DATE: 09/05/24
TO: All Bidders
FROM: David Cienfuegos, Purchasing Specialist
SUBJECT: Addendum 1 – Bid 686 Ventura College Global Garden Landscaping

A. Drawing L3.2 Low Voltage Lighting Plan

PROJECT
VENTURA COLLEGE
WORLD GLOBAL GARDEN QUAD
RENOVATION
4667 TELEGRAPH ROAD
VENTURA, CA 93003

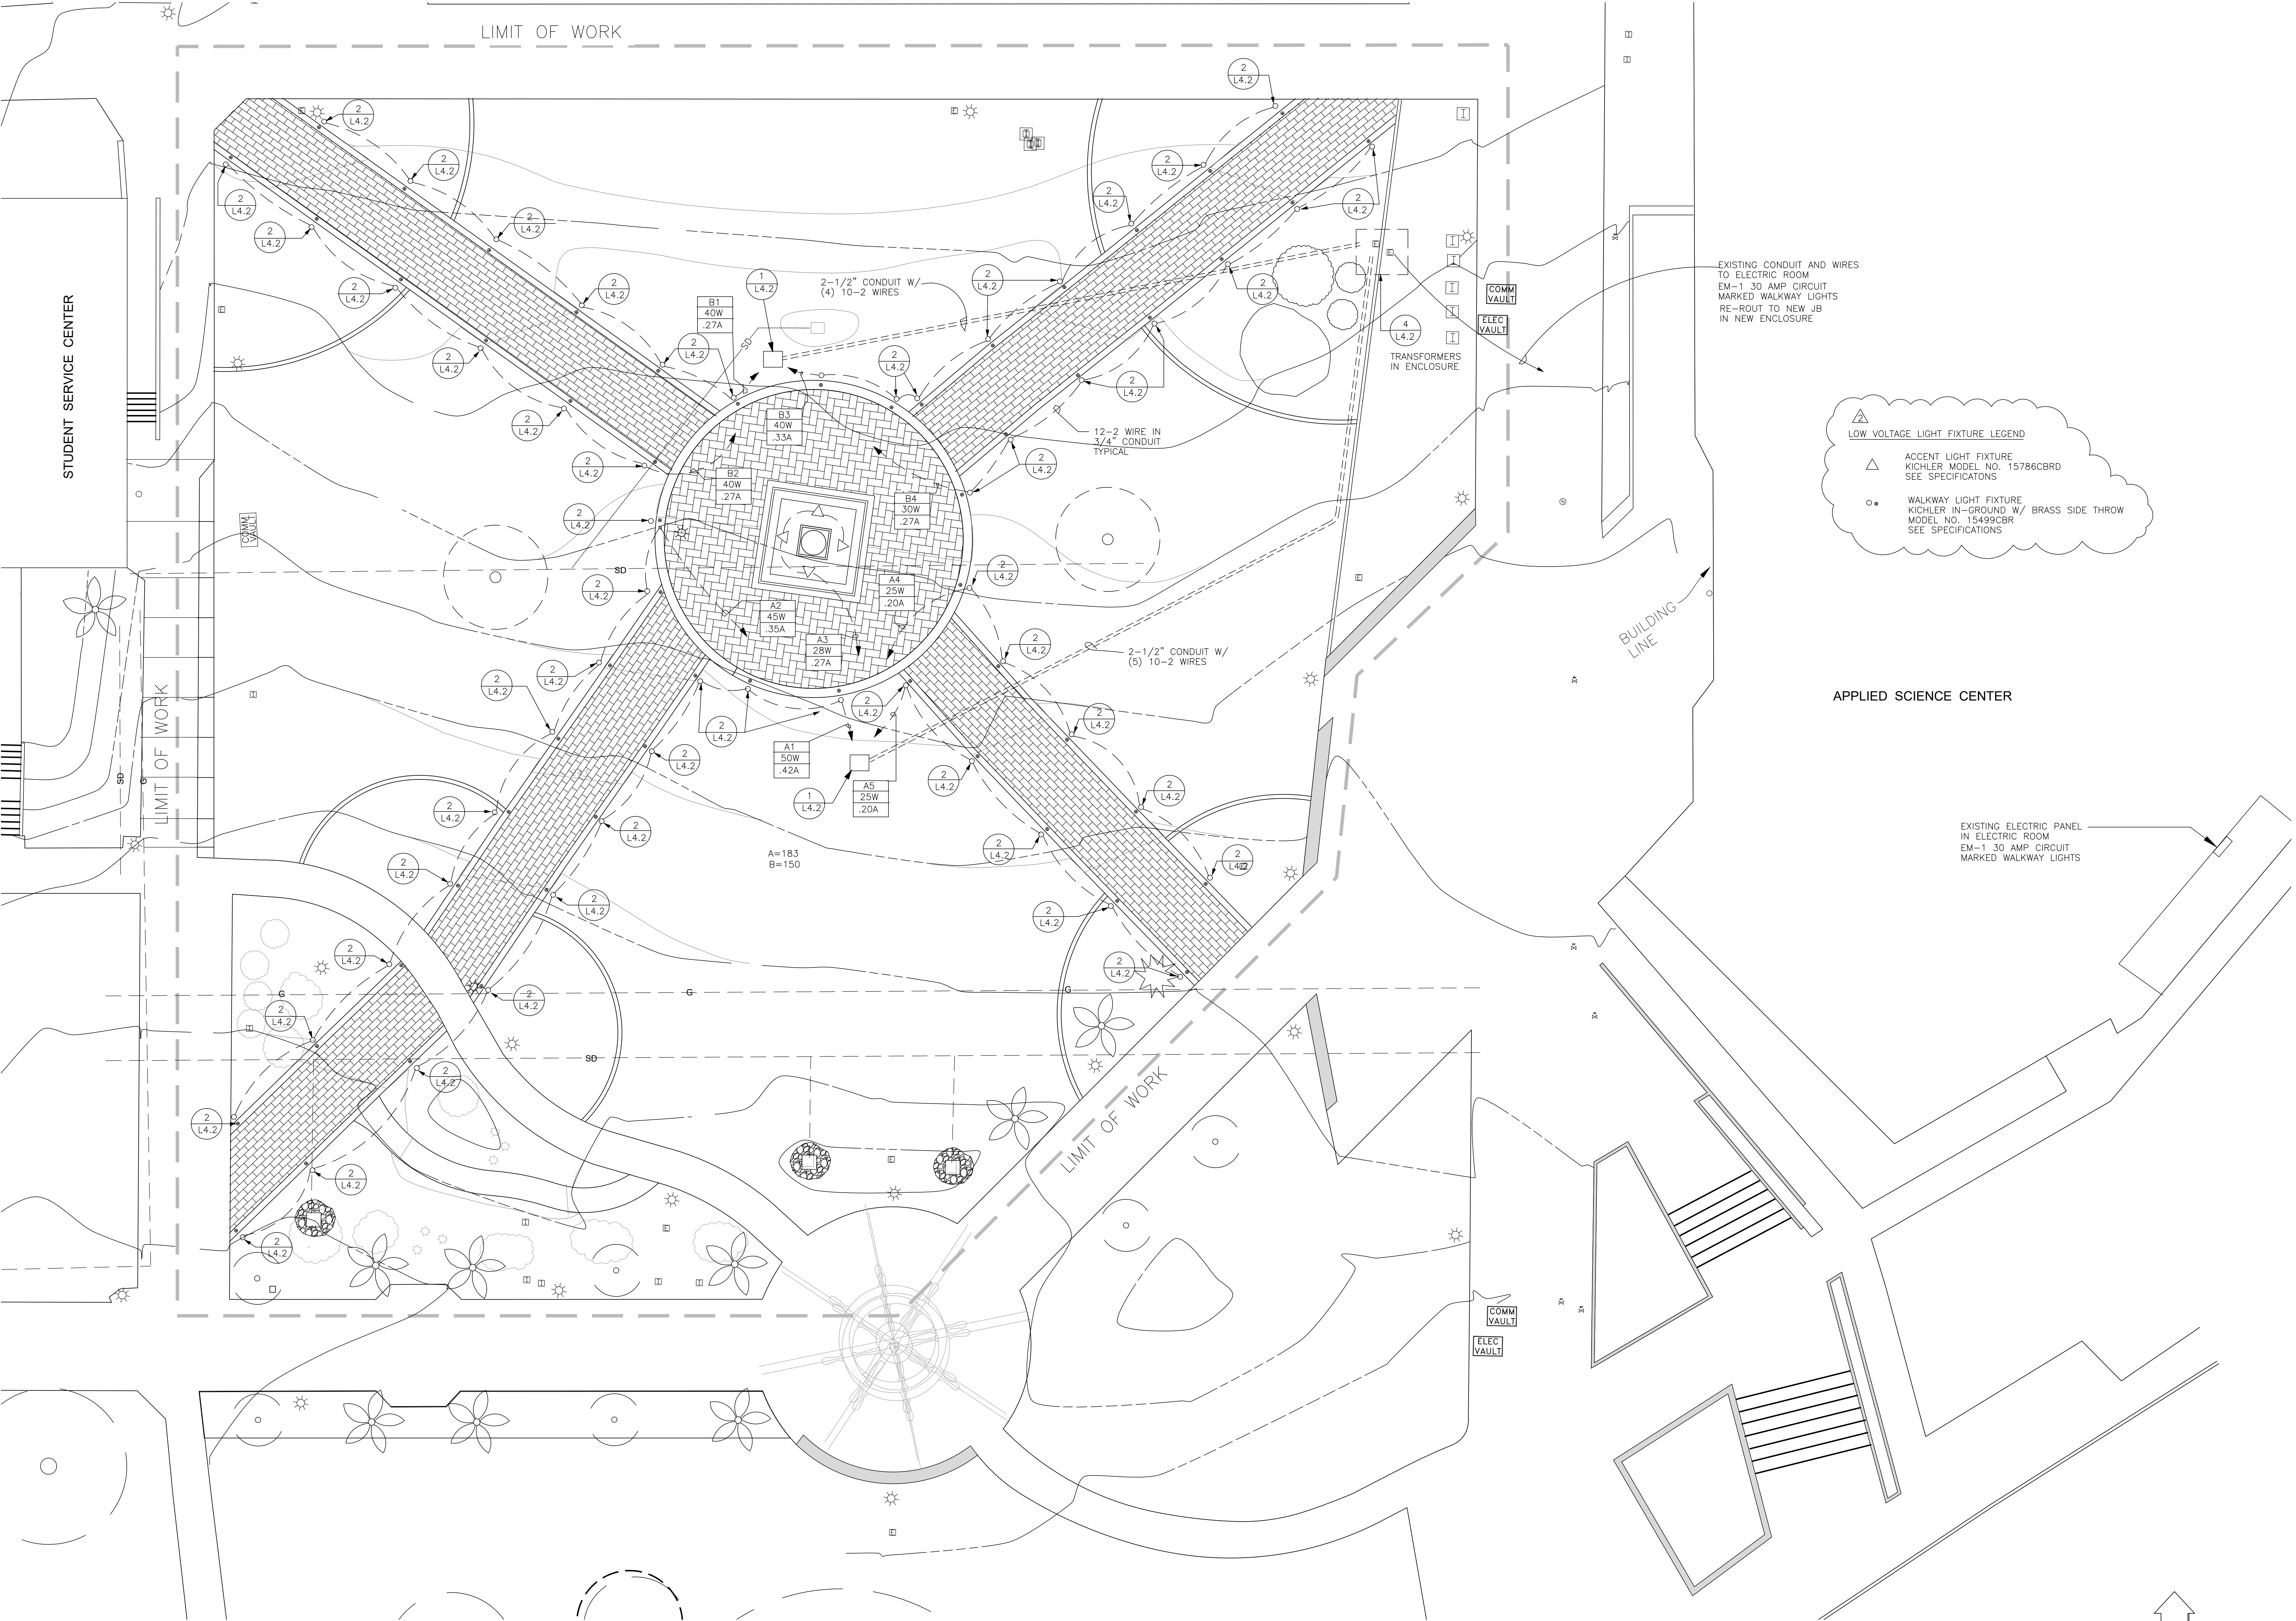
1. The light fixture indicated around the world globe sculpture are four large wall wash fixtures as described in Specifications Section 26 50 00 Low Voltage Lighting, para 2.05 Light Fixtures-Accent.
